Village of Arlington Heights
Plan Commission
Board Room, 3rd Floor
Arlington Heights Village Hall, 33 S. Arlington Heights Rd.
April 24, 2024
7:30 PM

A. 2201 N. Chestnut Ave Townhomes - 2201 N. Chestnut Ave & 315 W. Rand Rd. - PC#23-011
Preliminary Plat of Subdivision, Rezoning from R-1 to R-6 for Lot 2 and R-1 to B-2 for Lot 1, Comprehensive Plan Amendment, Special Use Permit to allow Minor Auto Repair on Lot 1, and Variations

REPORT OF THE PROCEEDINGS OF A PUBLIC HEARING
BEFORE THE VILLAGE OF ARLINGTON HEIGHTS
PLAN COMMISSION

RE: RED FLAG RESOLUTION - PC #24-002

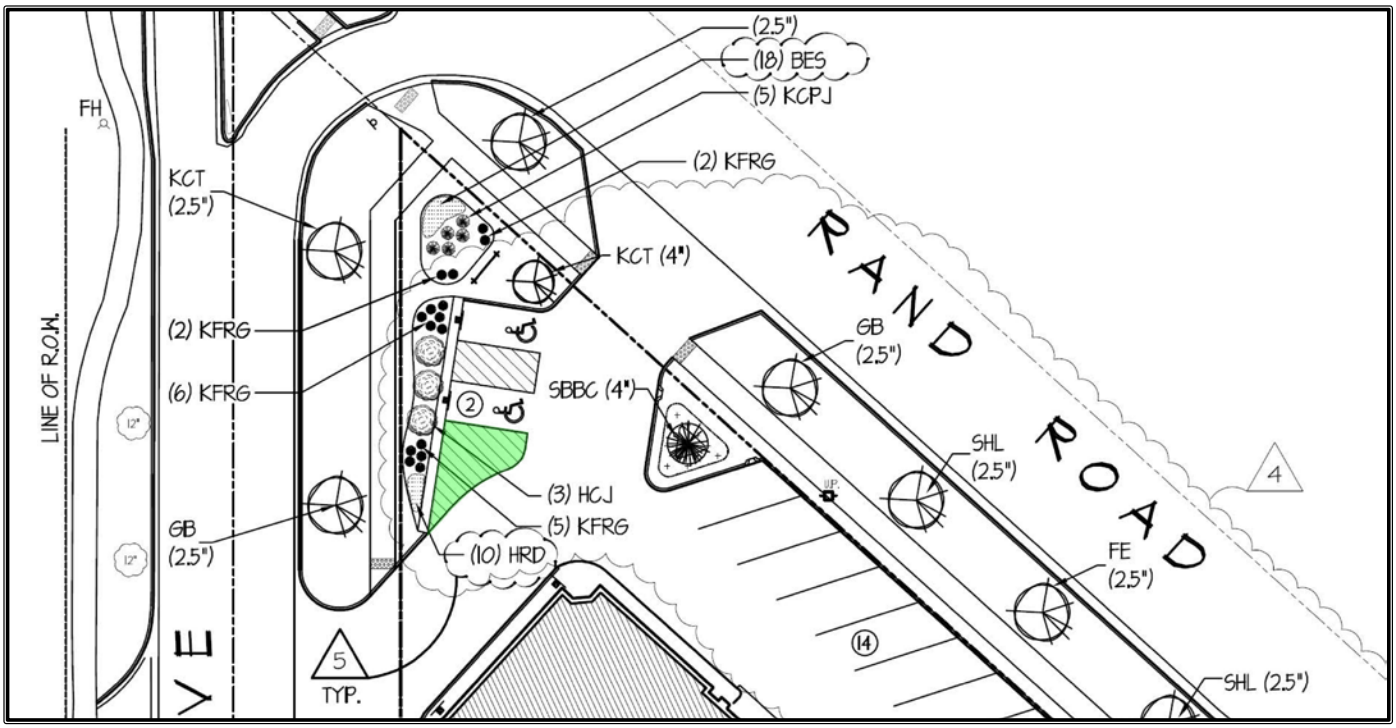
At the northern side of the site there is an area of existing pavement that is proposed to remain as striped asphalt adjacent to a parking stall. The graphic below shows this area in green.

Code requires that the ends of all parking rows include a curbed landscape island including a shade tree. The SDC recommends this area be converted to a landscape island including a shade tree and a condition of approval requiring such has been recommended below.

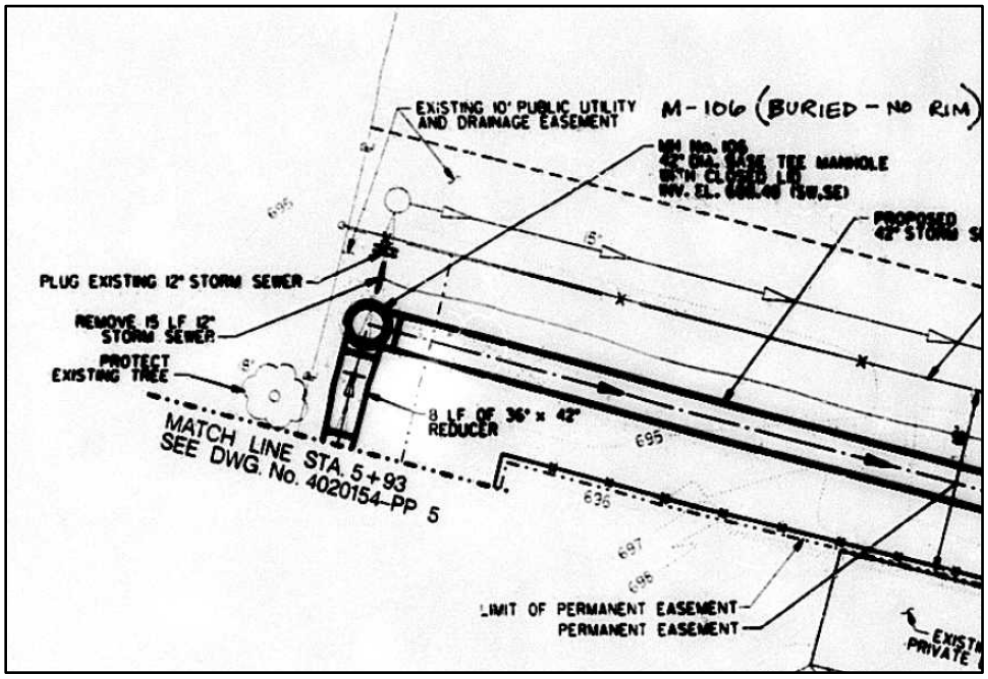
55. The petitioner's response to comment no. 42 is noted.
    a) The fee-in-lieu for the automotive site area (0.435 ac) that is not tributary to the detention vault is acceptable. Provide calculations to show the overall site (1.06 ac) volume requirement (0.392 ac-ft per our calculations); subtracting the volume provided of 0.205 ac-ft leaves a deficiency of 0.187 ac-ft = 8,146 cu ft = $8,146 as fee-in-lieu of detention.
    b) The proposed bioswales to address the area that currently sheet drains to Rand Road is acceptable.
    c) The 2002 as-builts from the Rand-Palatine Stormwater Management Phase I for the Central Detention Basin were provided, it appears the plans still do not accurately show the existing storm sewer. An image of the as-builts is below.

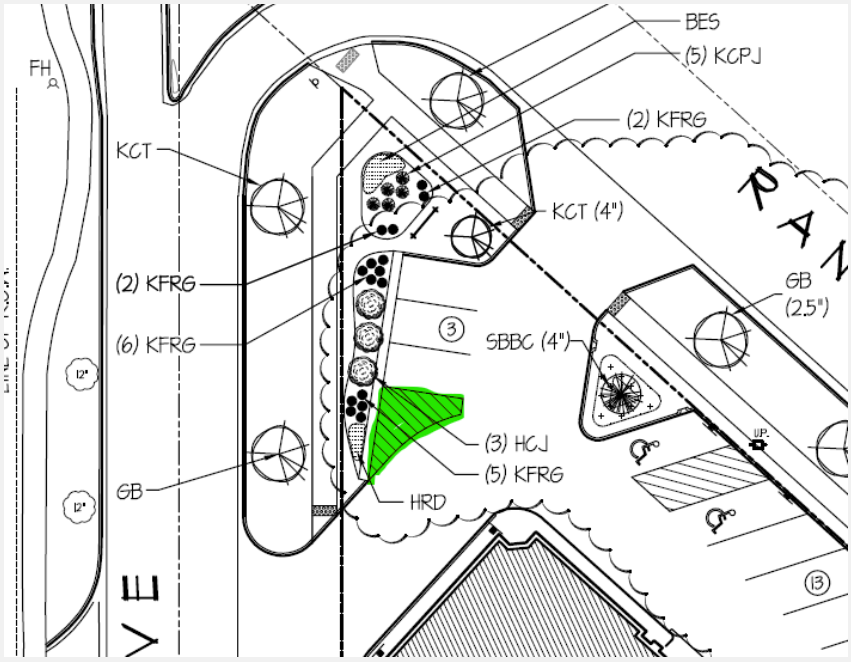
55. The striped area near the entrance off of Chestnut should be converted into a landscape island (see next page).
